Dist	COUNTY	ROUTE	POST MILES TOTAL PROJECT	SHEET No.	TOTAL SHEETS
03	Yol,Sac	80	R10.9/R11.7, M0.0/M10.4	2	1012

3 **REVISED PER ADDENDUM No. 3 DATED MAY 19, 2011**

TYPICAL CROSS SECTIONS

STATE OF CALIFORNIA - DEPARTMENT OF TRANSPORTATION
Caltrans®
NORTH REGION
OFFICE OF DESIGN SOUTH
DESIGN BRANCH S7

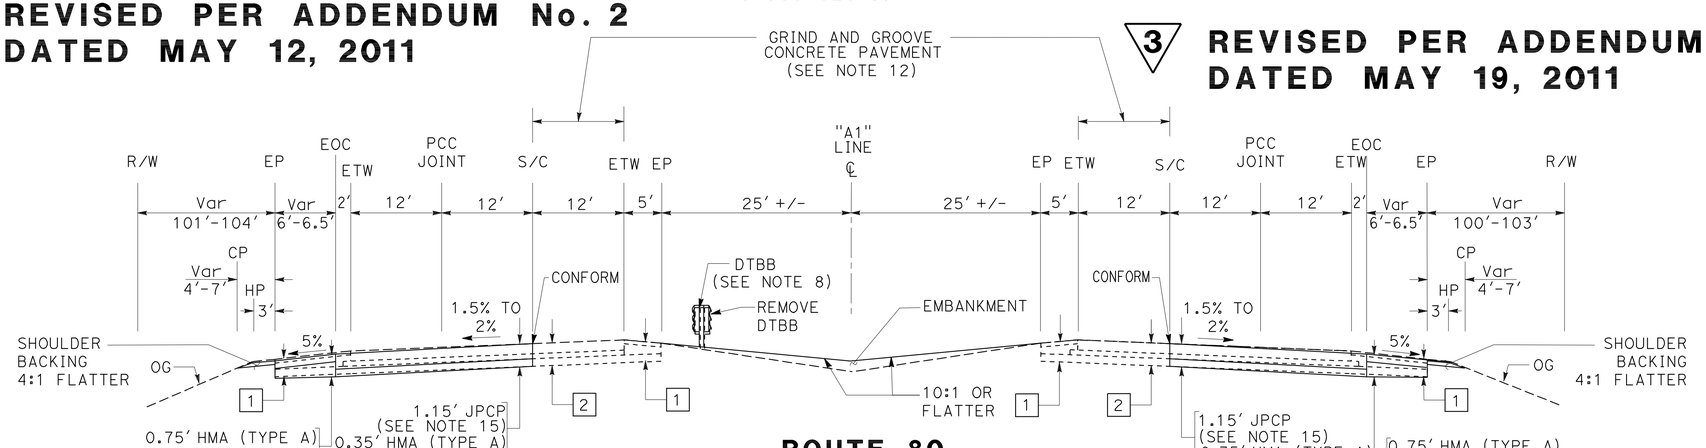
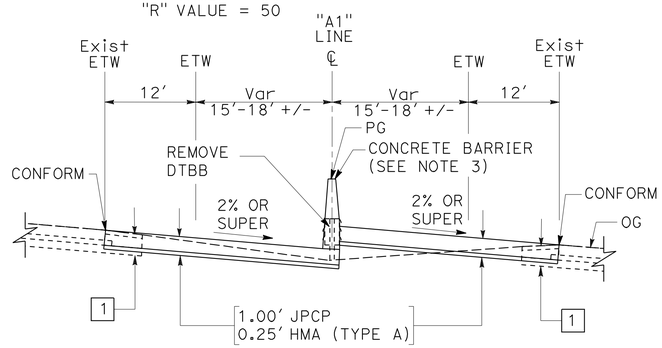
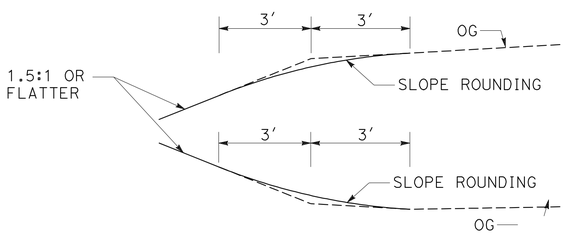
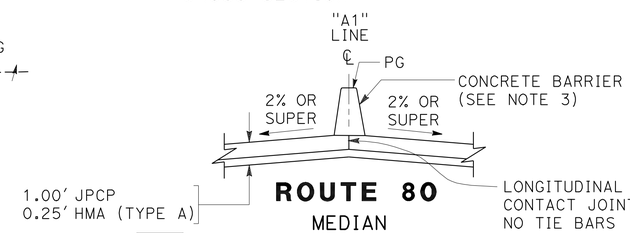
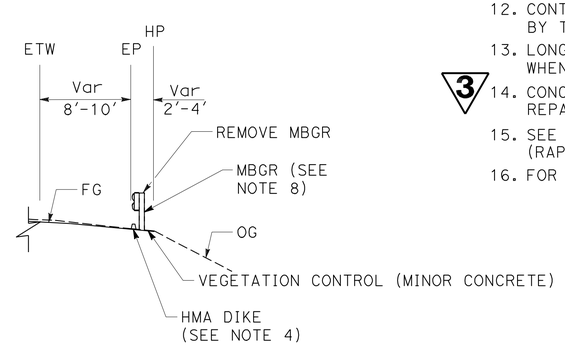
13. LONGITUDINAL FORMS SHALL BE USED TO PROVIDE CORRECT CROSS SLOPE WHEN REQUESTED BY ENGINEER.
14. (3) CONCRETE PAVEMENT SHALL BE ~~GROUND AND~~ GROOVED AFTER REPAIR/REPLACEMENT OF CONCRETE PAVEMENT.

LAYOUT

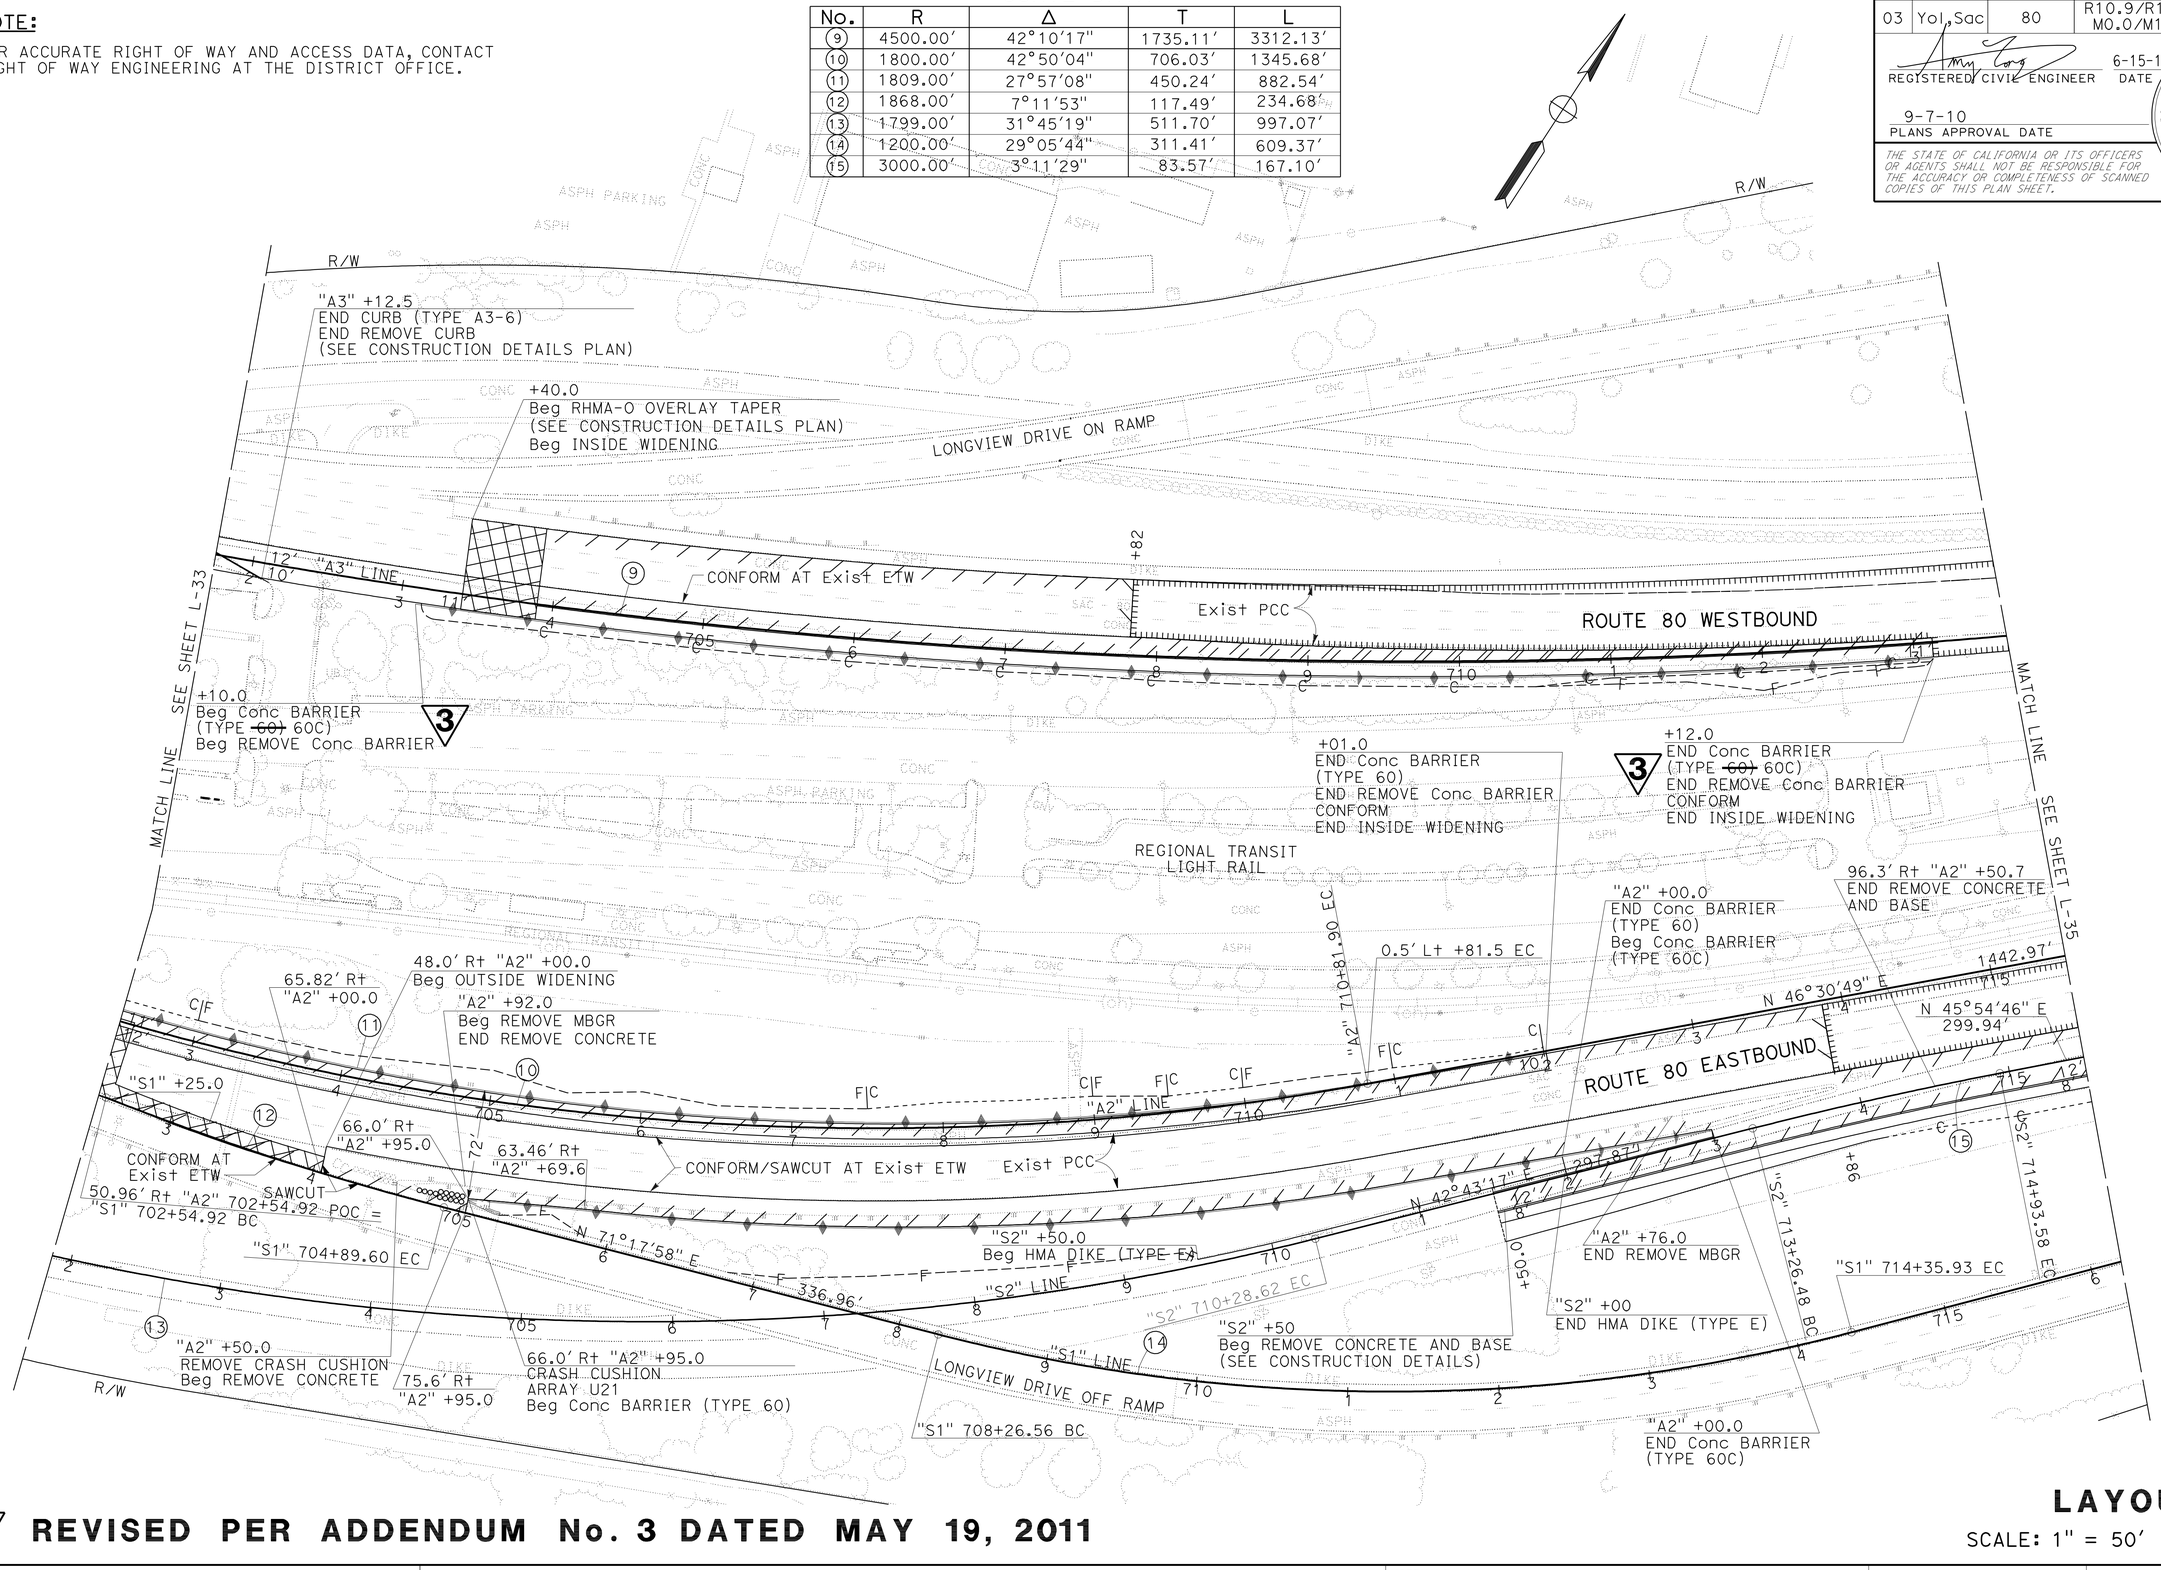
3 REVISED PER ADDENDUM No. 3 DATED MAY 19, 2011

CONSTRUCTION DETAILS

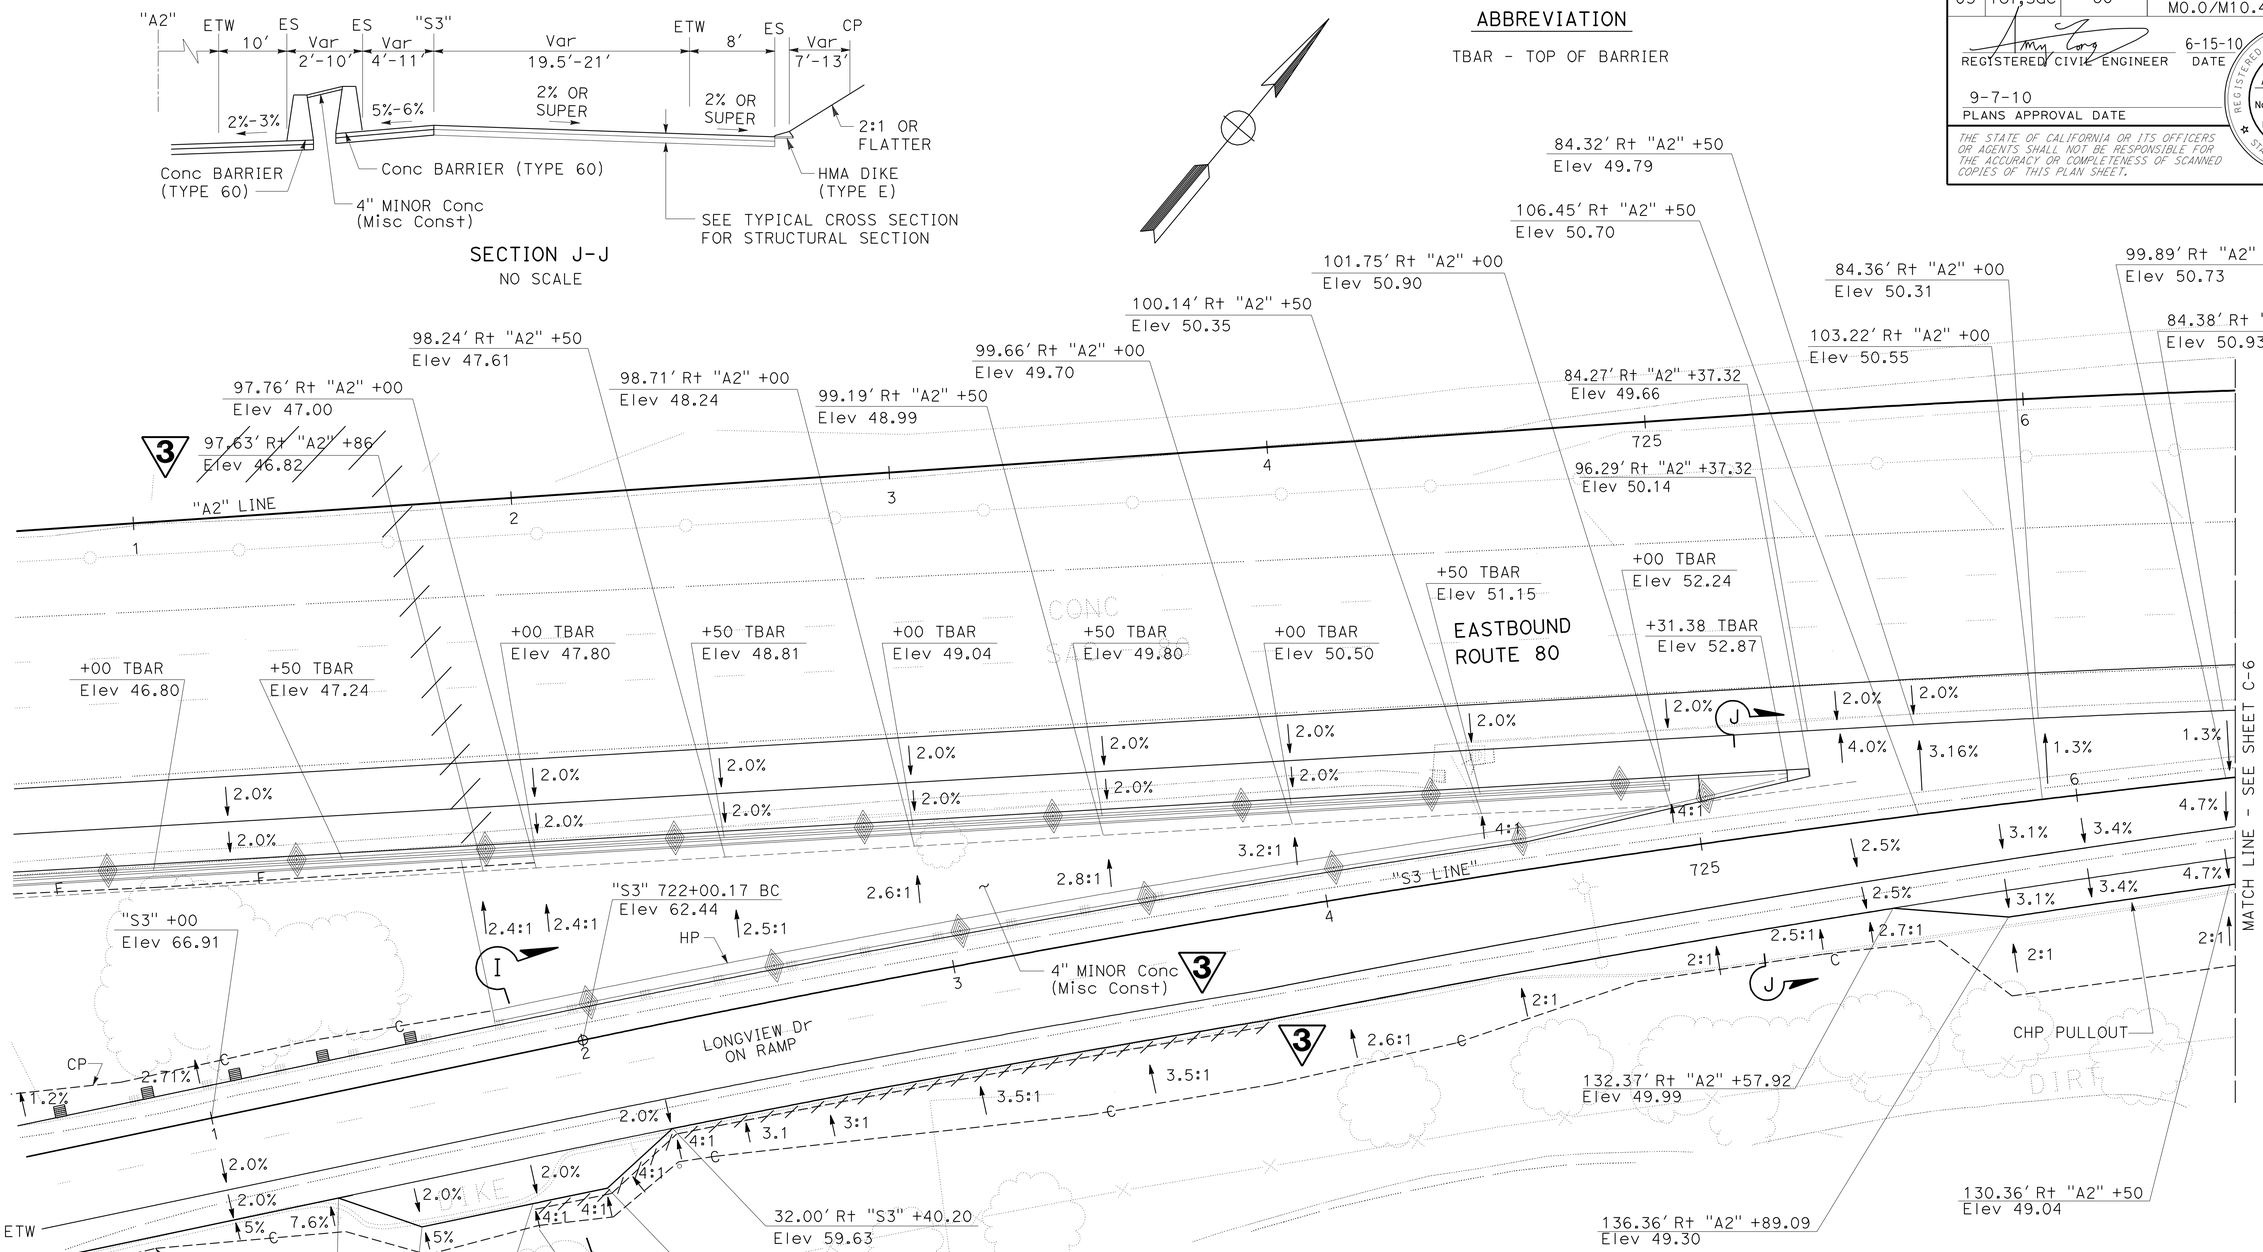
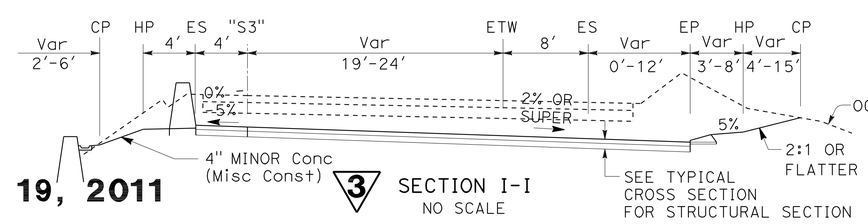
REVISED PER ADDENDUM No. 3 DATED MAY 19, 2011

CONSTRUCTION DETAILS
NO SCALE
C-8

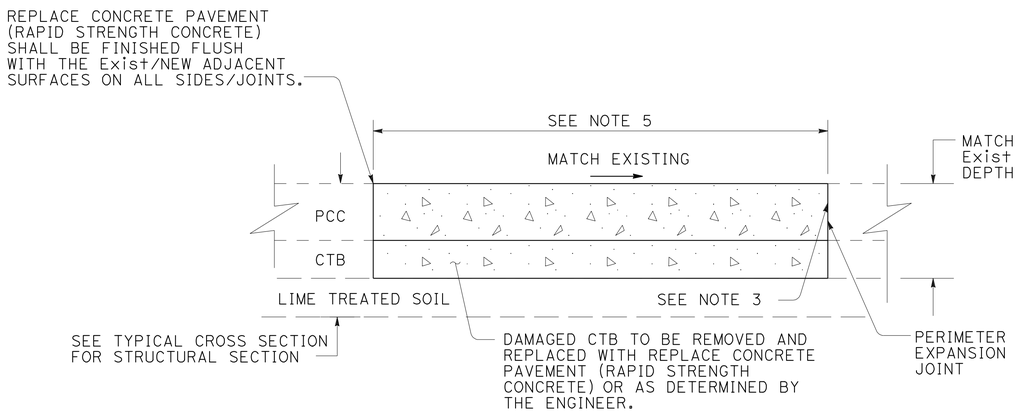
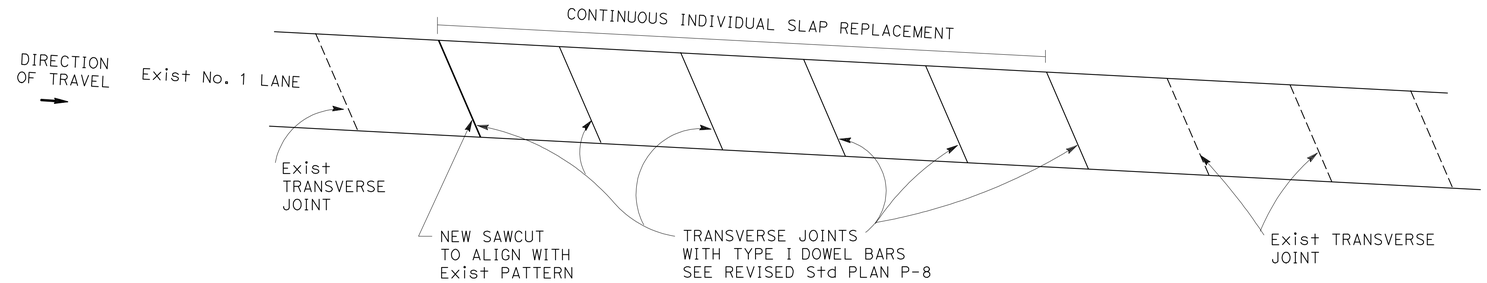
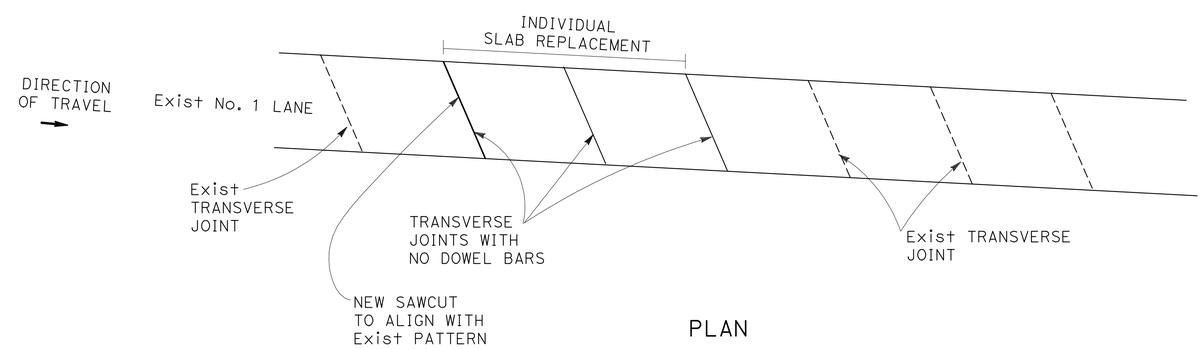
3 **REVISED PER ADDENDUM No. 3 DATED MAY 19, 2011**

CONCRETE PAVEMENT LANE SCHEMATICS AND JOINT DETAIL

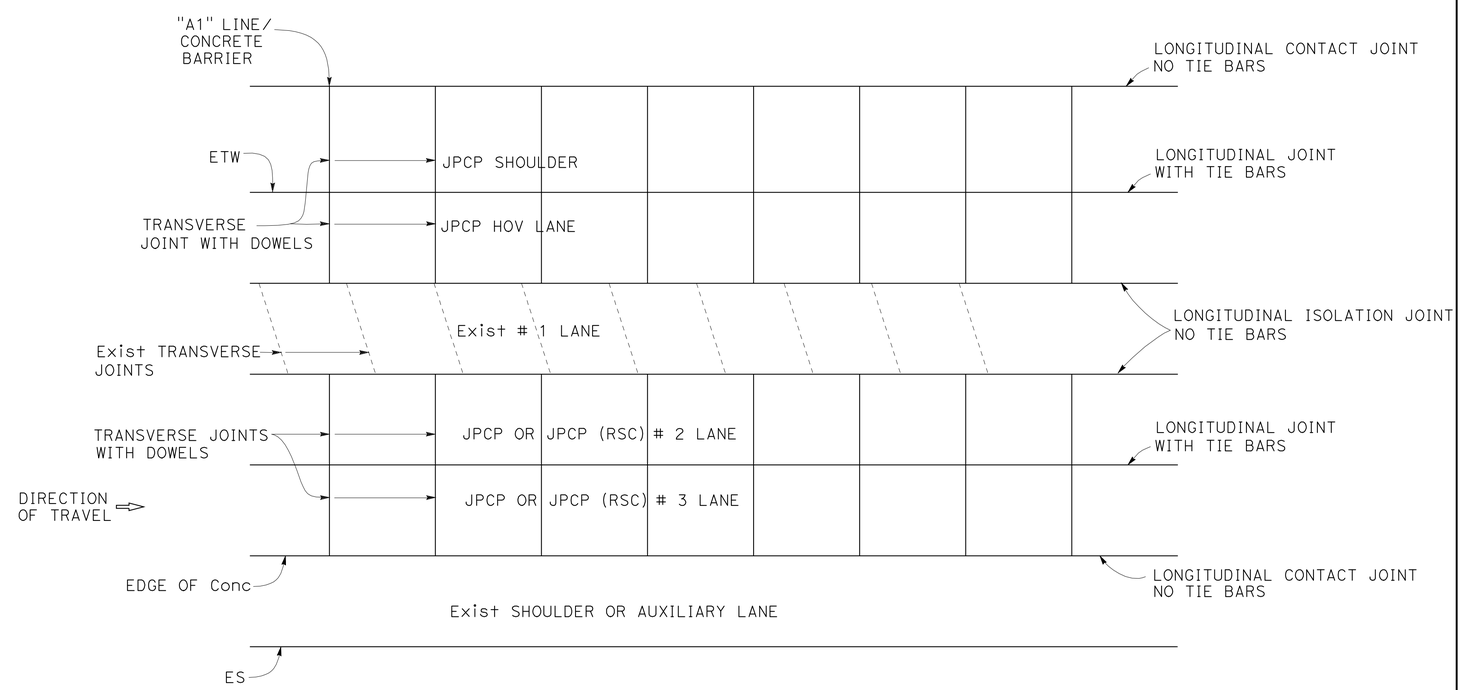
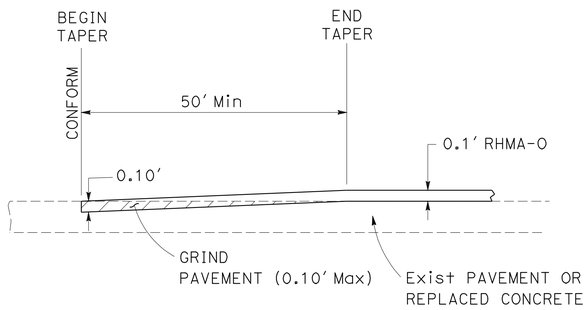
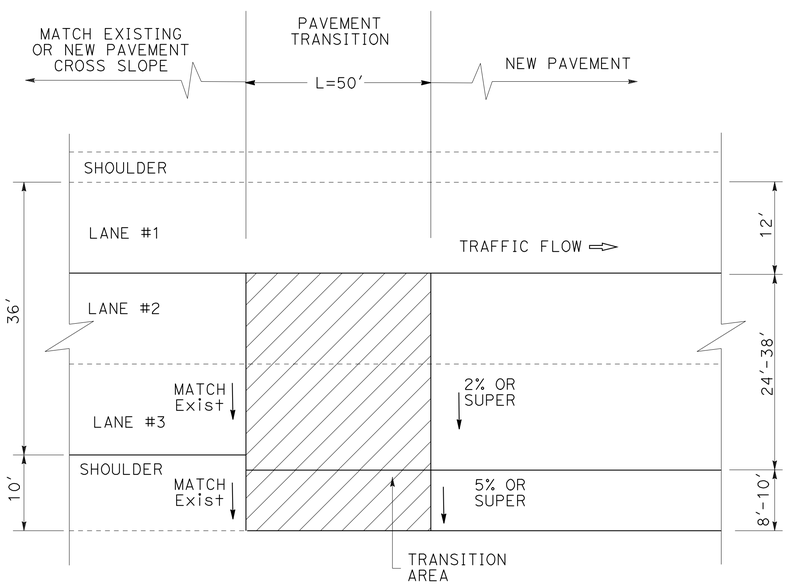
3 **REVISED PER ADDENDUM No. 3 DATED MAY 19, 2011**
